IN RE: ENVIRONMENTAL IMPACT STATEMENT SCOPING COMMENTS FOR COMANCHE PEAK NUCLEAR POWER PLANT UNITS 3 AND 4

**Environmental Impact Statement Comments for Comanche Peak Units 3 and 4 -Submitted on Behalf of Texas State Representative Lon Burnam, the Sustainable Energy and Economic Development (SEED) Coalition, Public Citizen, True Cost of Nukes and Debbie Harper**

IN RE: ENVIRONMENTAL IMPACT STATEMENT SCOPING COMMENTS FOR COMANCHE PEAK  
NUCLEAR POWER PLANT UNITS 3 AND 4

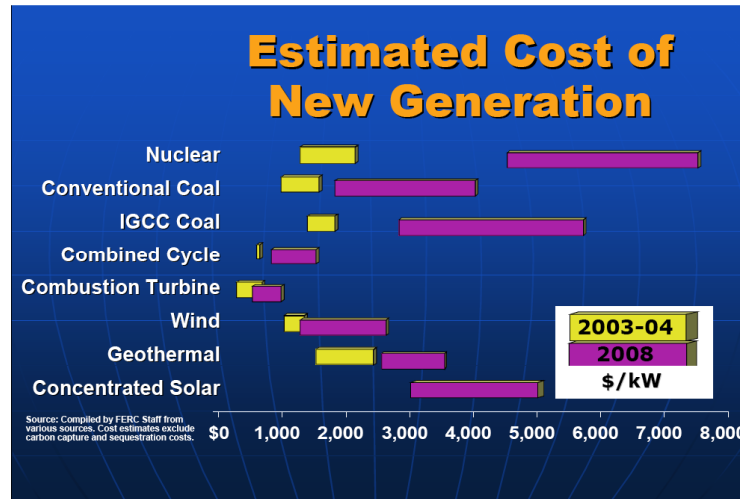
The Comanche Peak emergency evacuation plan assumes that 100% of the affected population from a radiological emergency would be evacuated. p. 7.2-3. The model is further compromised because it does not adequately account for evacuees that are transported 25 miles from the Comanche Peak site as they "disappear" from the emergency evacuation analysis. *Id.* Accordingly, the results of the dose and dollar risk assessments for severe accident analysis are understated in the Comanche Peak environmental report Table 7.2-5. The EIS should not assume that 100% of the affected population will be evacuated. Rejecting this assumption requires that the data in Table 7.2-5 be adjusted to account for increased dose risk, dollar risk, early fatalities, latent fatalities, and water ingestion dose risk. Moreover, there should be an accounting for evacuees and the doses to which they have been exposed even if those evacuees are moved 25 miles beyond the Comanche Peak site.
